Urban Design Brief - 150 Dun Skipper Drive Residential

Prepared by Novatech, January 20, 2025

Response to Urban Design Comments on Preliminary Design (provided October 21, 2024)

COMPOSITE SITE PLAN
(CONCEPTUAL)

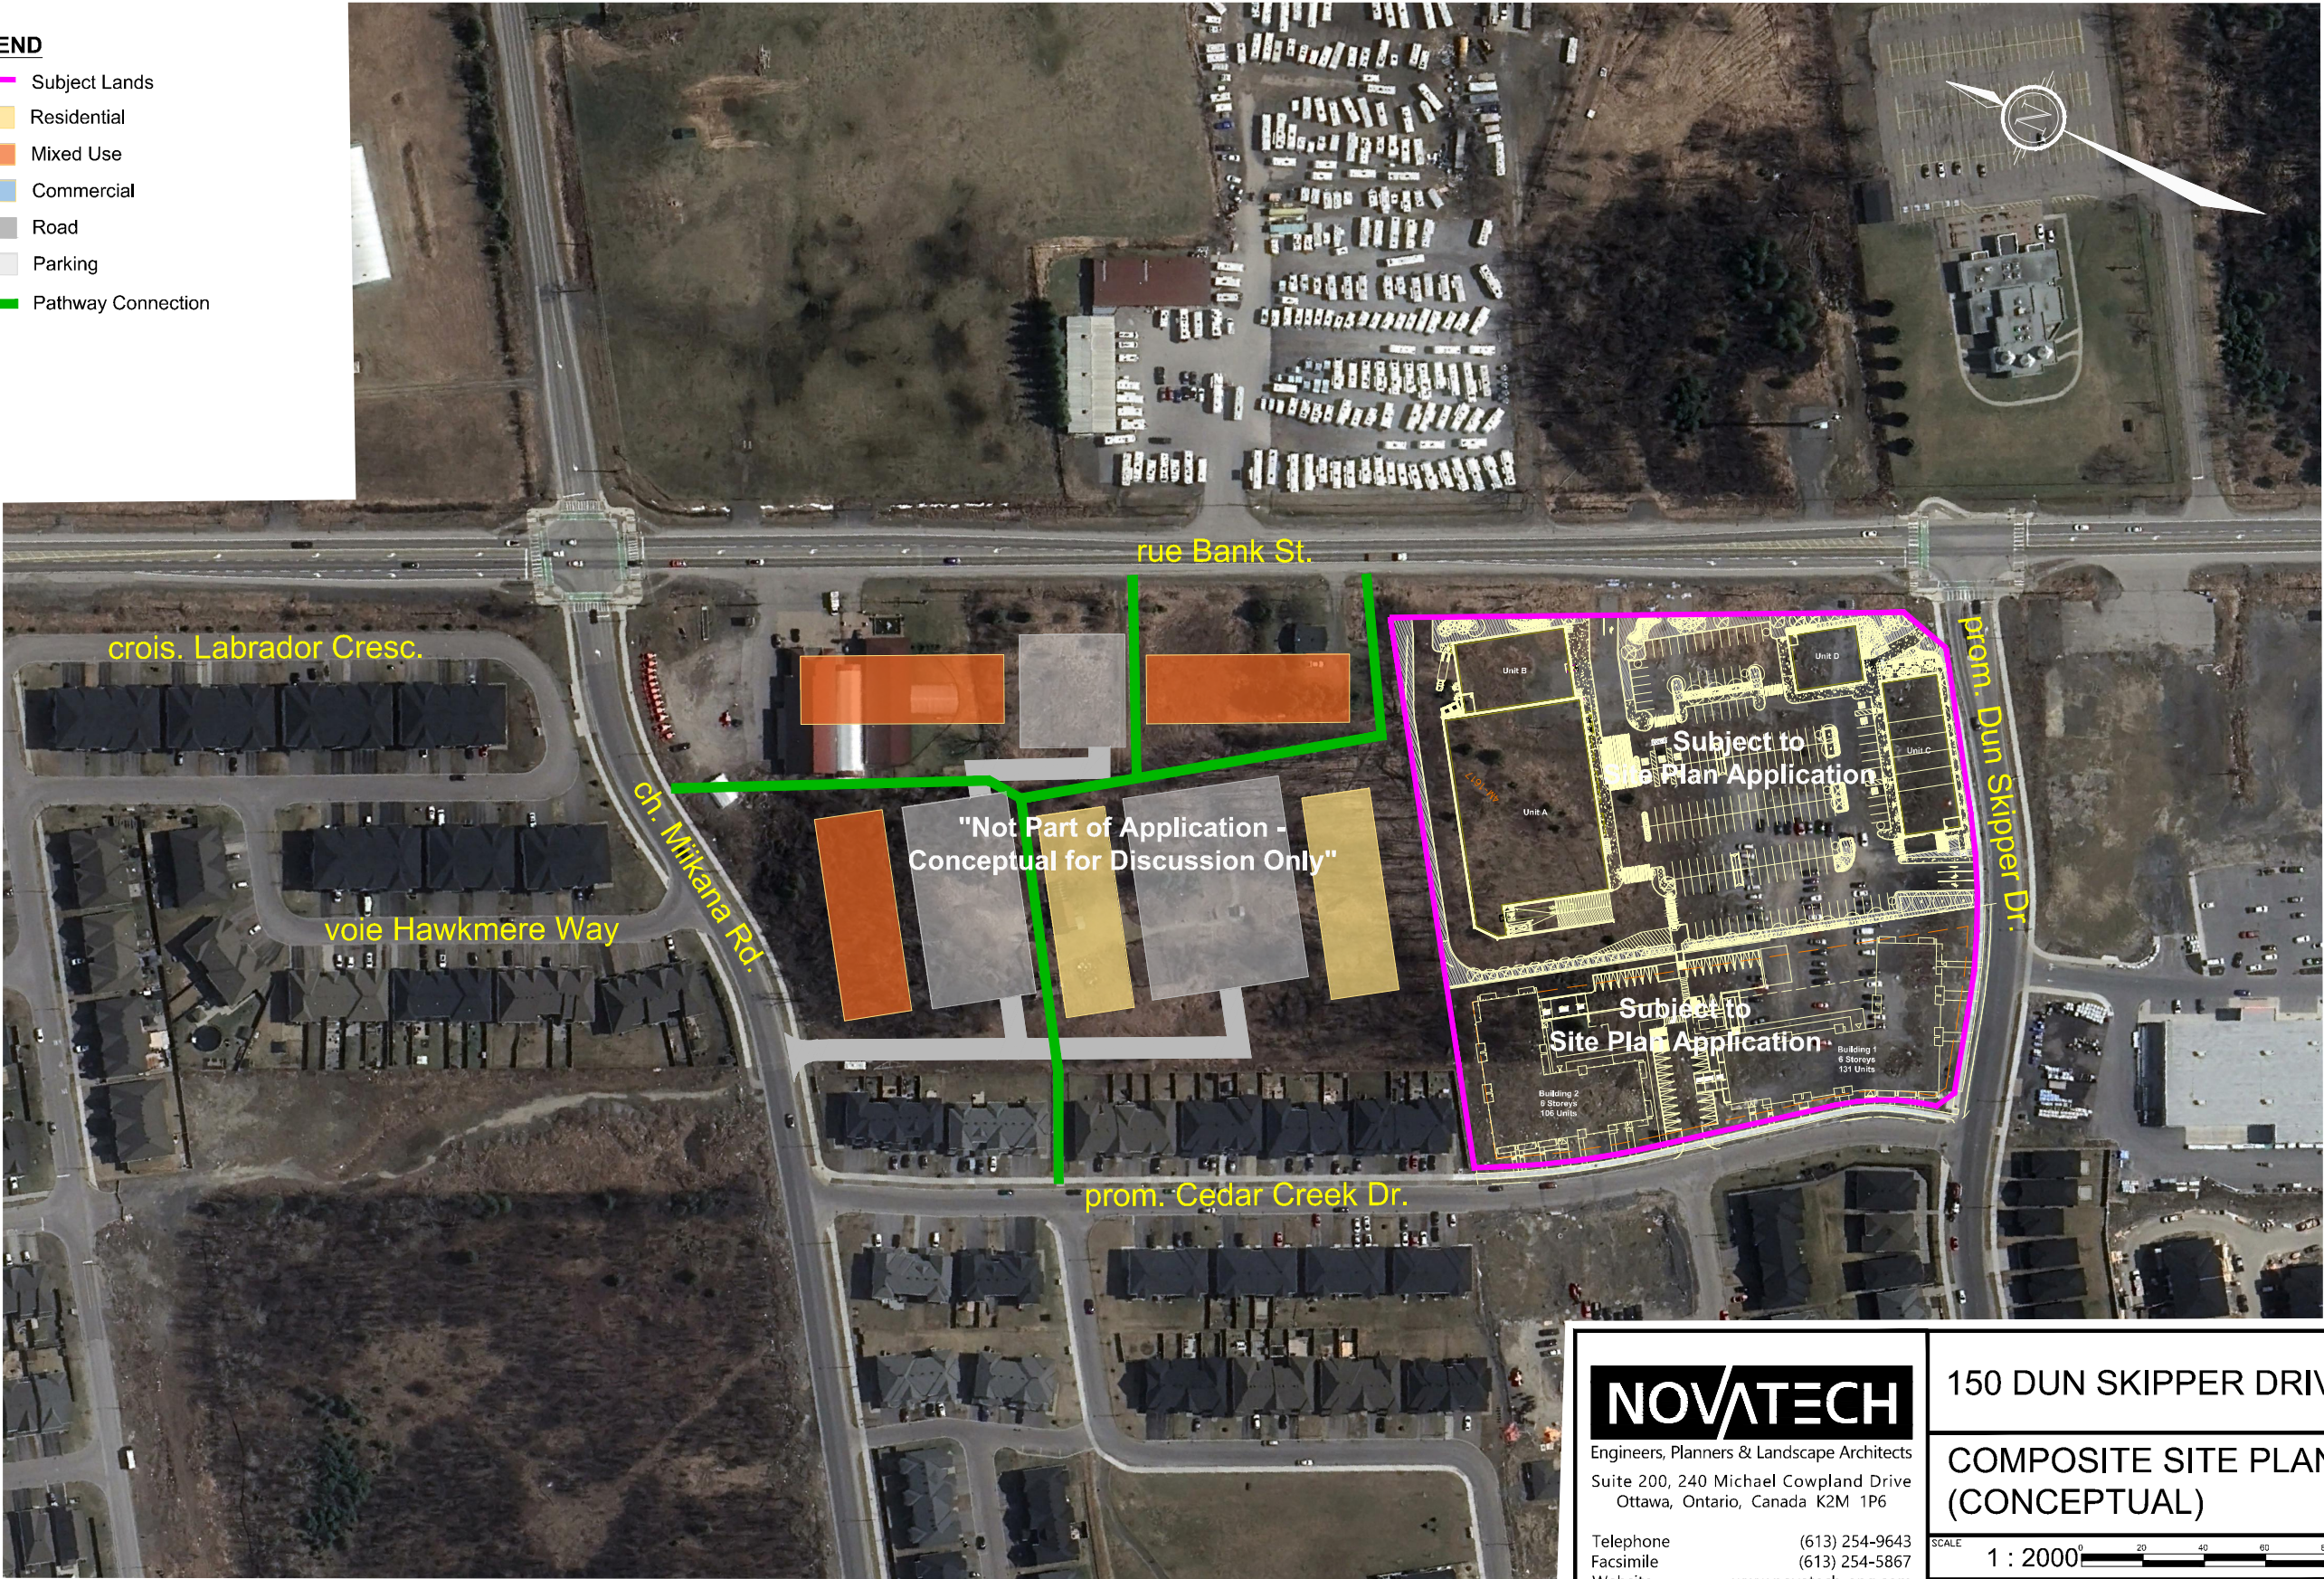
16.For each of the Mixed-Use areas along Bank Street, a composite site plan for the entire Mixed-Use area must be approved prior to the first development application for the area. This composite site plan must demonstrate how all land uses will work together, including surrounding land uses, how the CDPs guidelines can be achieved, and how individual proposals will fit within the overall plan.

Response: A Composite Site Plan is included in the Urban Design Brief.

SITE PLAN
1:300

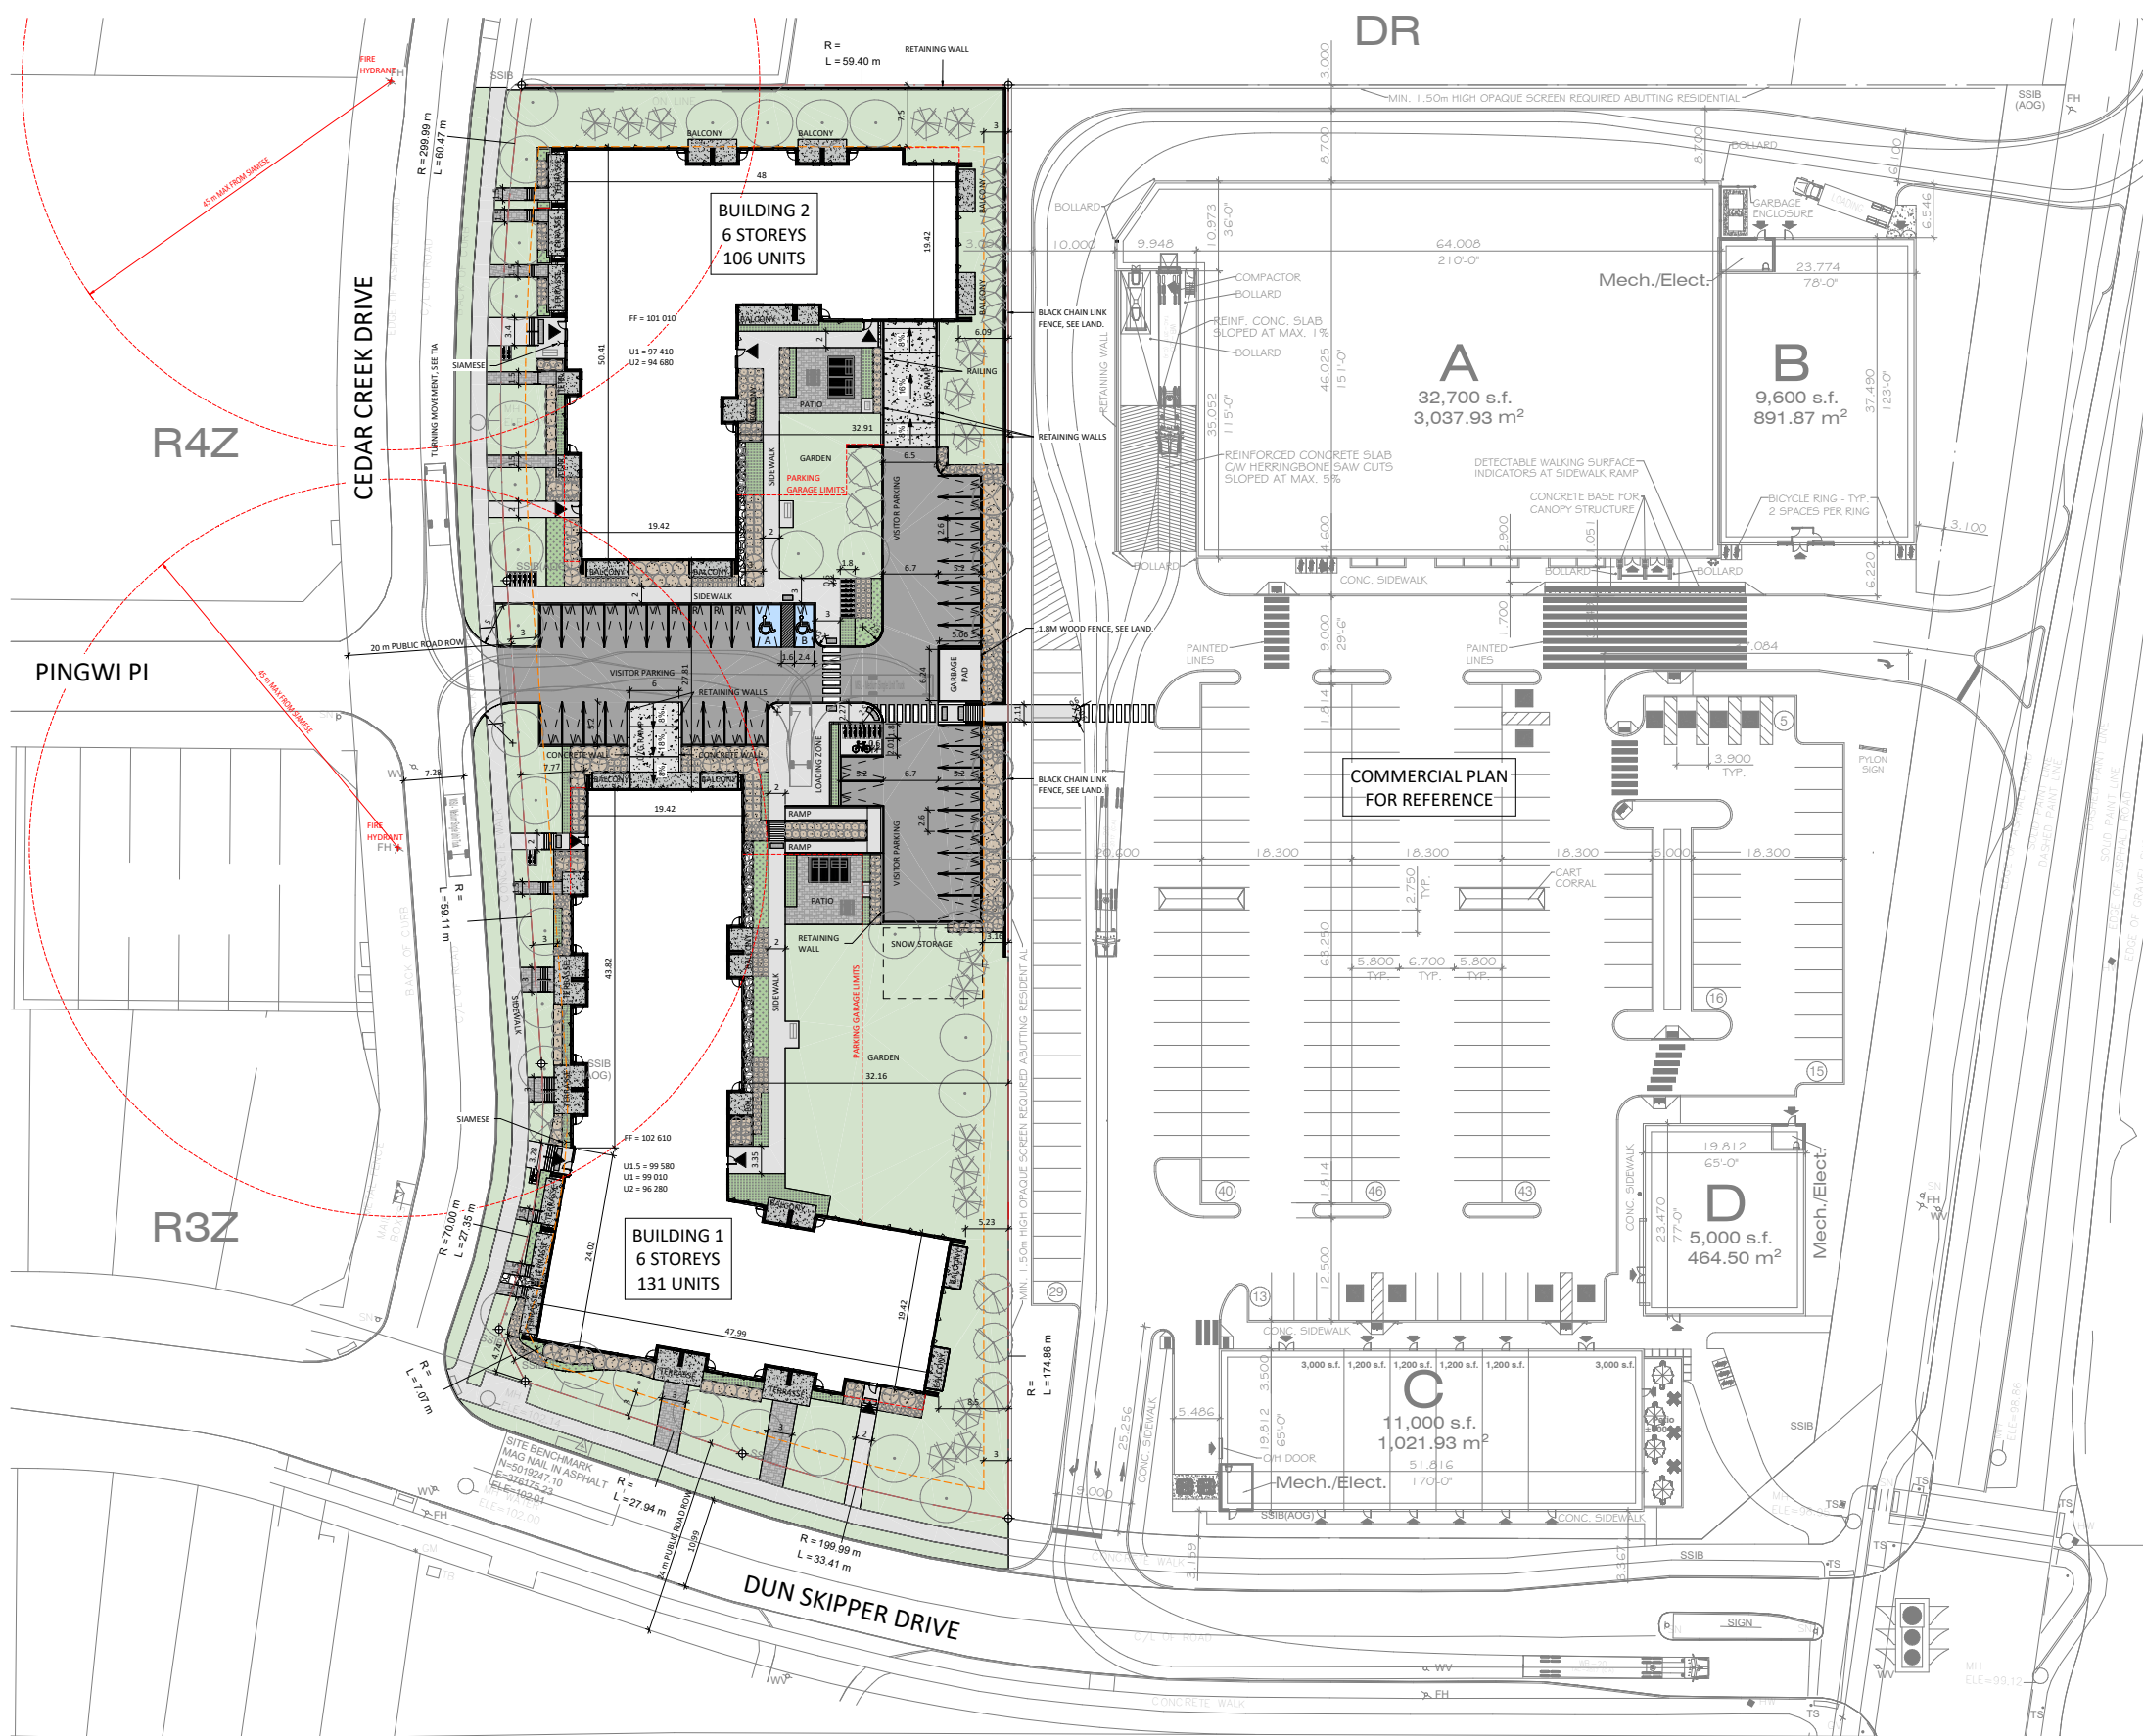
17.Consider providing public access through the site from Pingwi Place to Bank, as this will be a desire line for residents. Please ensure that direct safe, pedestrian connections are provided.

Response: This will be provided. It is shown on the revised Site Plan.
